Report
Prepared for
Maddocks Lawyers on behalf of
Lovely Banks Development Group

**Amendment C395 to the Greater
Geelong Planning Scheme**

traffic: evidence

Maddocks Lawyers on behalf of
Lovely Banks Development Group
Our reference 16658T-REP01-F01

Figure 3.3: Comparison of Activity Centre Walkable Catchments

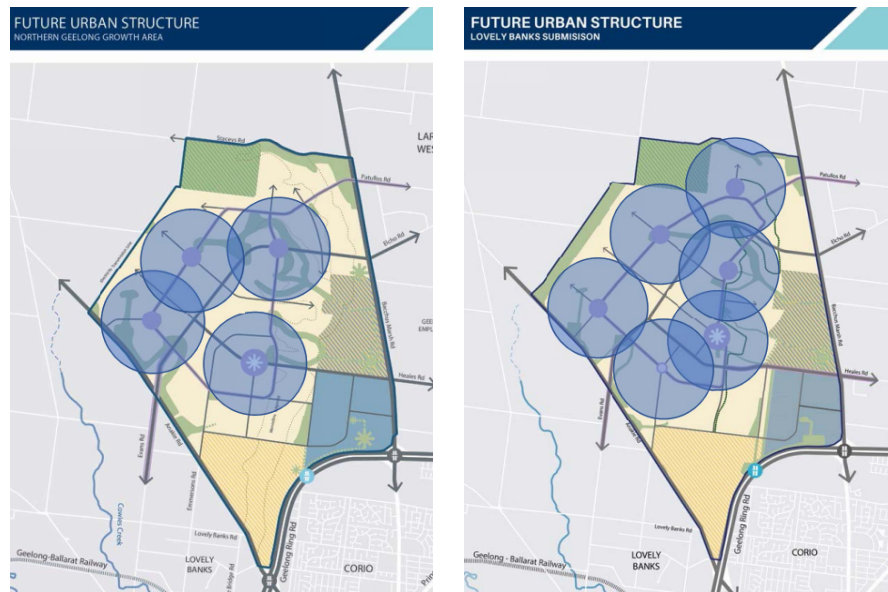
- 3.1.10 The activity centre arrangement in the Framework Plan suggests that 41% of the residential areas will be beyond the walkable catchments of the activity centres, compared with just 23% in the LBDG submitted arrangement.

- 3.1.11 Those living outside the walkable catchments for the activity centres would be more likely to choose an alternative mode to access their daily needs, through a combination of cycling, public transport or driving.

- 3.1.12 Based on the above, it can be reasonably expected that there would be a higher proportion of walking trips by residents in the LBDG plan than the Framework Plan. In addition, the LBDG plan could be expected to result in fewer trips by car as a result of more residents travelling by foot. This would be a positive transport outcome.

Figure 4-1: Proposed shifting of Activity Centres in context of realigned Elcho Road

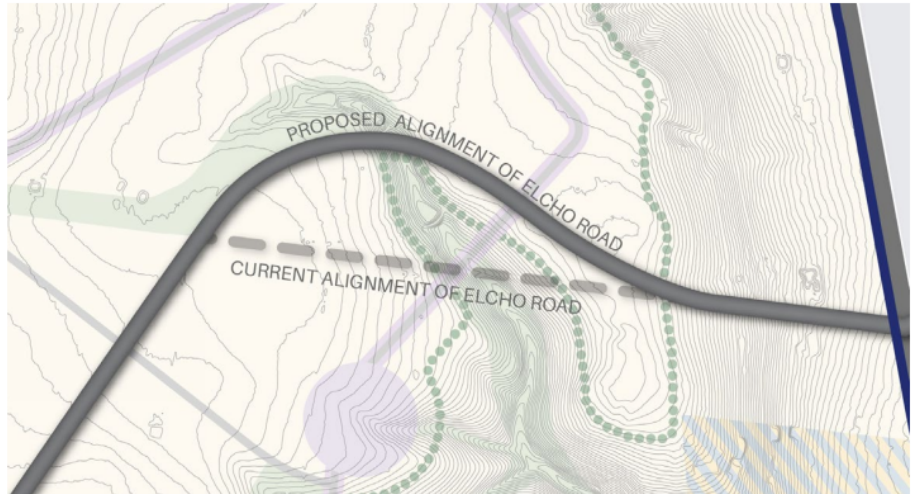
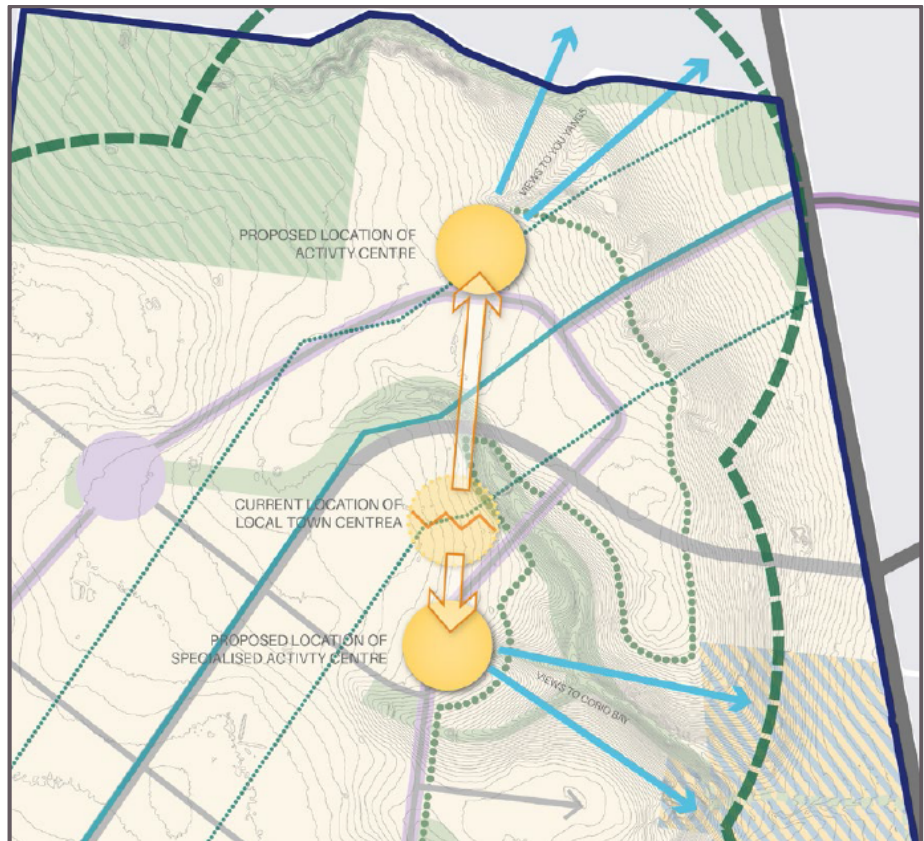
- 4.1.3 I have reviewed the relevant transport considerations associated with this proposal. My assessment of the impact of the changes on the transport function of the road considers both the realignment and the changes to the activity centre locations. Plans prepared by Beveridge Williams to inform the proposed LBDG alignment were provided to me by my instructing solicitors and are included in Appendix A (horizontal alignment) and Appendix B (vertical alignment) respectively. I have reviewed the relevant parameters adopted in the horizontal and vertical alignment designs.

5. The GTA traffic modelling that informed the Framework Plan (modelling scenario PC04B) showed Elcho Road as carrying between 15,000vpd and 18,000vpd where it passes through the activity centre

and would have a four-lane configuration with additional turning lanes at the intersection. The high level of traffic and wide road reservation in this location poses difficulties in delivering an activity centre that caters well for sustainable transport modes such as walking and cycling, owing to greater crossing distances and delays at the signalised crossings. The LBDG outcome, having activity centres that are accessed by narrower connector level streets carrying much lower levels of traffic (~8,000vpd) would result in activity centres that can better integrate sustainable transport modes.

6. Elcho Road would likely carry less activity centre related traffic with the LBDG proposal as it would pass through the edges of the two relocated NAC catchments as opposed to passing through the centre of one as per the Framework Plan. This would result in an improved traffic carrying function for Elcho Road.

7. The minor localised realignment of Elcho Road, i.e. the introduction of curvature, would unlikely have a negative impact on its traffic carrying function as an arterial road.

CLEVER AND CREATIVE CORRIDOR – ULTIMATE CONFIGURATION

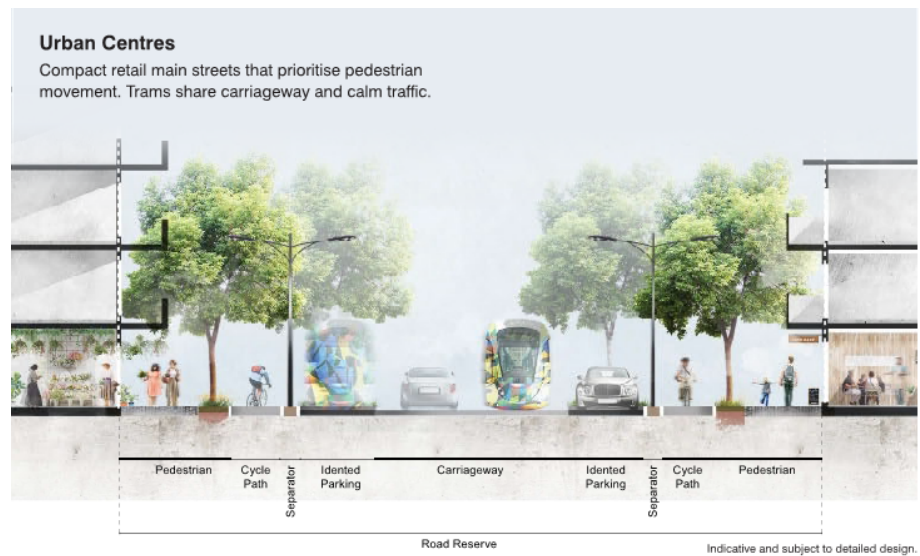
5.1.8 In my opinion, the Framework Plan should be amended to remove the reference to an explicit 14m reserve being required to deliver the outcomes sought by the Clever and Creative Corridor. As discussed above, there are a number of outcomes for the configuration of the corridor that could achieve the objectives sought for the corridor whilst at the same time responding to the particular requirements of the adjoining land uses.

5.1.9 I note that the Objectives and Strategies for the Clever and Creative Corridor in the proposed drafting of Clause 21-20 *Northern and Western Geelong Growth Corridors* are not so rigid as the Framework Plan. I would support the wording as proposed below as being a sufficiently flexible and clear guide for the preparation of cross sections for the Clever and Creative Corridor to be undertaken as part of the Precinct Structure Plans such that the reference to a 14m reserve could be removed from the Framework Plan.

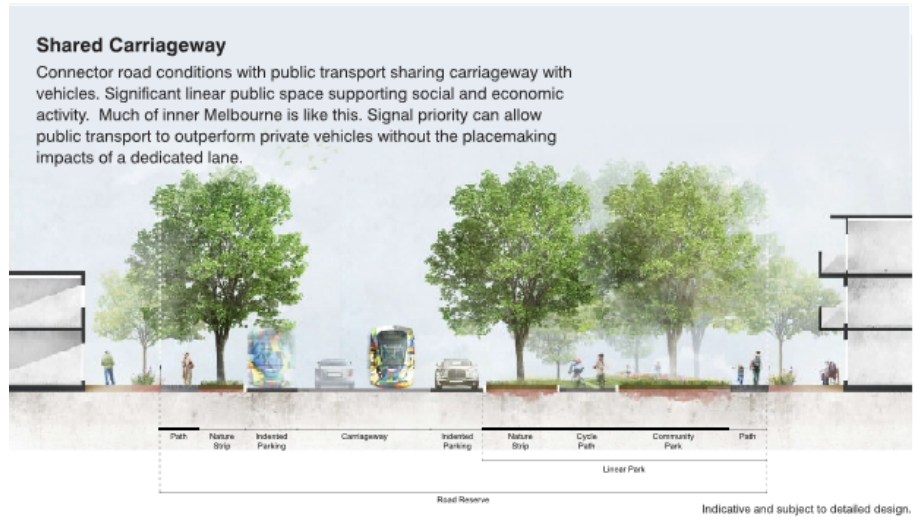
- 5.1.6 My opinions on the transport considerations of the 'Urban Centres' cross section example are as follows:

- It does not deliver a dedicated, separated public transport as is sought by the Framework Plan. This could result in slower journey times for passengers as the services pass through the urban centres and detract from their use.

- In my view, there exists a further iteration of the above plan to be considered that would achieve a separated public transport corridor by replacing the indented parking lane with a traffic lane.

- A further iteration to the above to be considered involves removing indented parking and allowing public transport services to share the roadspace with vehicles. Removing the parking would reduce the level of disruption associated with vehicles manoeuvring to and from parking spaces and/or looking for vacant kerbside parking. Reducing what is termed 'side friction' by removing kerbside parking would mean delays to public transport services would be reduced such that the sharing of road space does may not adversely impact on the operation of public transport services passing through the urban centres so as to detract from their utilisation.

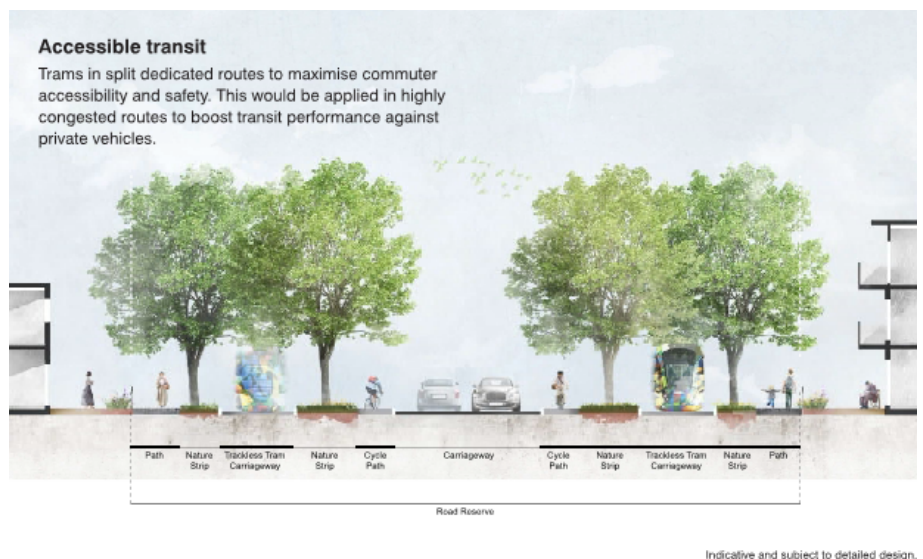
5.1.7 My opinions on the transport considerations of the 'Shared Carriageway' cross section example above are as follows:

- This cross section does not achieve a dedicated public transport corridor, which may be suitable in locations where vehicle traffic would not impact on the operation of the public transport services.

- Similar to the alternative options described above for the urban centres cross section, public transport could be given greater priority in the example above by removing the indented parking and providing public transport its own carriageway or removing the parking and allowing vehicle traffic to share the space with public transport, thereby reducing side friction impacts as I discussed previously.

- The Aecom report suggests that for purposes of offering a consistent and efficient future public transport service along the C&CC, a primary route alignment should be selected through each growth area, which in relation to the 'loops' in the C&CC alignment, means one arc of the loop may become part of the primary PT route alignment and the other becomes a secondary route. That report also goes on to suggest that the secondary routes could either be used as part of the high priority public transport corridor, or that the corridors could be used for alternate purposes or retained in their short-term passive state. A variation on the above cross section could be appropriate for the secondary arc of the C&CC loops.

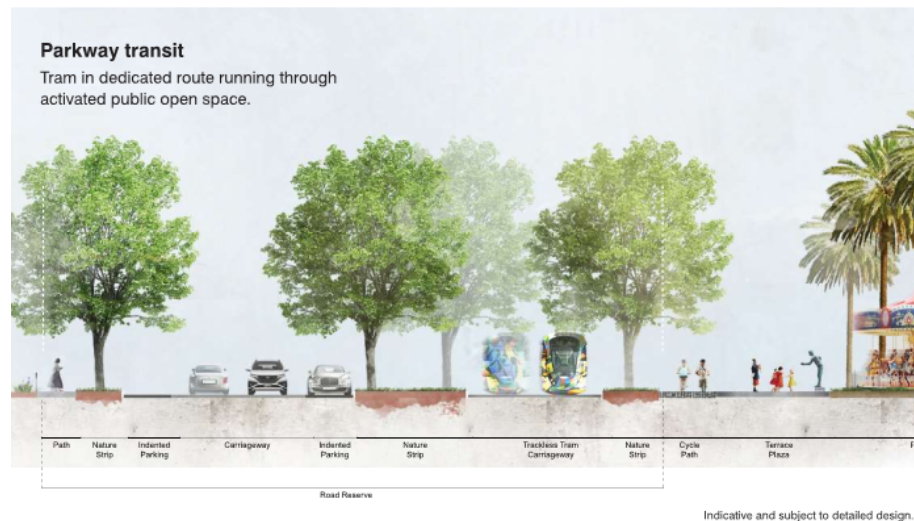
- Locating the public transport services in reserves to the side as opposed to the median results in greater levels of conflict with turning vehicles and is described in the Aecom report as the reason why a central median option was identified. I agree in principle with the rationale in the Aecom report.

- My understanding of the Framework Plan is that it contemplates this outcome as being accepted, with the exception of the cycle path being located outside the road reserve in this example, i.e. it states 'side running reserve' where appropriate which would appear to be the case in the example described above.

Figure 6.1: LBDG's proposed split staging of Heales Road East PSP

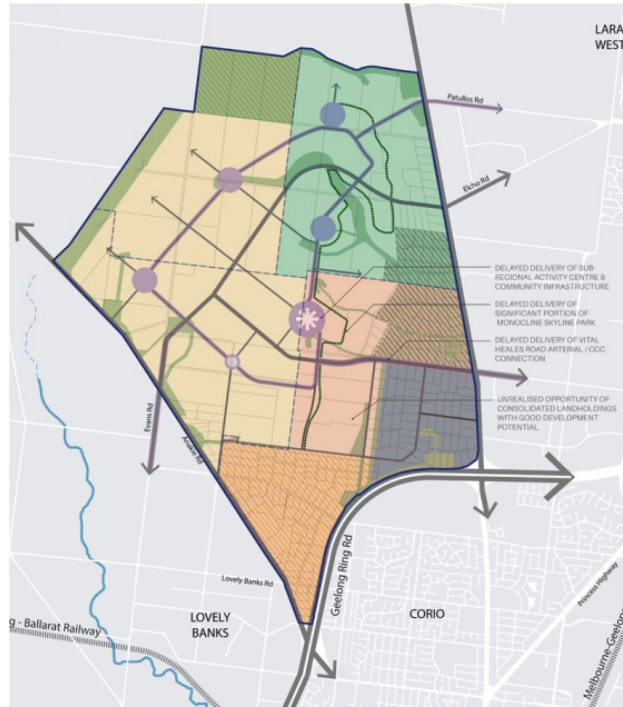
- 6.1.2 I have reviewed the potential transport impacts of bringing forward the western portion of the Heales Road East PSP, which would involve earlier delivery of the second portion of the sub-regional activity centre.

- Being a sub-regional activity centre, traffic movements will largely be derived from the surrounding local catchment.
 - The remaining section of the Heales Road East PSP, in its undeveloped state may mean that Heales Road is not able to be delivered in its ultimate four lane configuration at the time the land in question is brought forward. There is however scope to upgrade the unsealed section of Heales Road to a sealed two-lane standard between Houston Road and the activity centre.

- As I discussed previously, Heales Road is modelled to carry between 17,270vpd and 18,640vpd between Bacchus Marsh Road and the C&CC. Prior to the development of the balance of the Heales Road East PSP, the level of traffic carried on this section is likely to be less such that it would be operating within the capacity of 18,000-20,000vpd associated with its two-lane configuration.

- On this basis, the potential inability to upgrade Heales Road to its ultimate 4-lane carriageway does not restrict the proposal to bring forward the western portion of the Heales Road East PSP.
